PLANNING, ZONING, & BUILDING DEPARTMENT
PZ&B Staff Memorandum: Town Council Development Review

SUBJECT: ZON-23-014 (ARC-22-243) 302 SEABREEZE AVE (COMBO)

MEETING: AUGUST 09, 2023

EXIST. REAR SITE WALL VARIANCE @ GENERATOR 2
 SCALE: 1/2" = 1'-0"

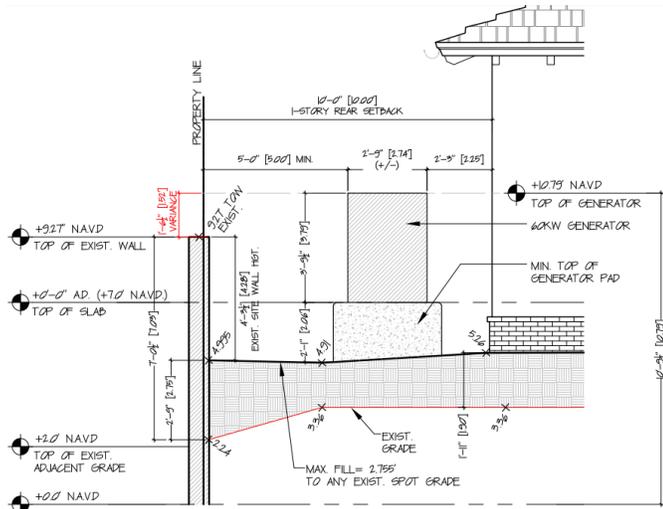
Code Section	Required	Proposed	Variance
Sec. 134-1729(1)(d)	Generator to be completely screened from neighboring property with a masonry wall	Partially screened by existing masonry wall	1' -6 ½" Unscreened

The site plan for the property locates the mechanical equipment in the east (side) and south (rear) yards. The mechanical equipment within the east yard is located either outside of the required side yard setbacks or is screened with code compliant masonry walls. The rear equipment yard adjacent to the south wall of the garage contains a 60kW generator unit within a yard setback. The generator is required to be screened from adjacent properties with a masonry wall as high as the equipment.

A masonry site wall that is proposed to remain on the rear property line measures 7'-0 1/2" in height when measured from the neighboring grade, already exceeding the 7' maximum wall height allowed by Code. As mechanical equipment is required to be placed at 7' NAVD, the generator exceeds the height of the existing wall. Sheet SP-3 of the architectural plans provides a variance diagram depicting the request.
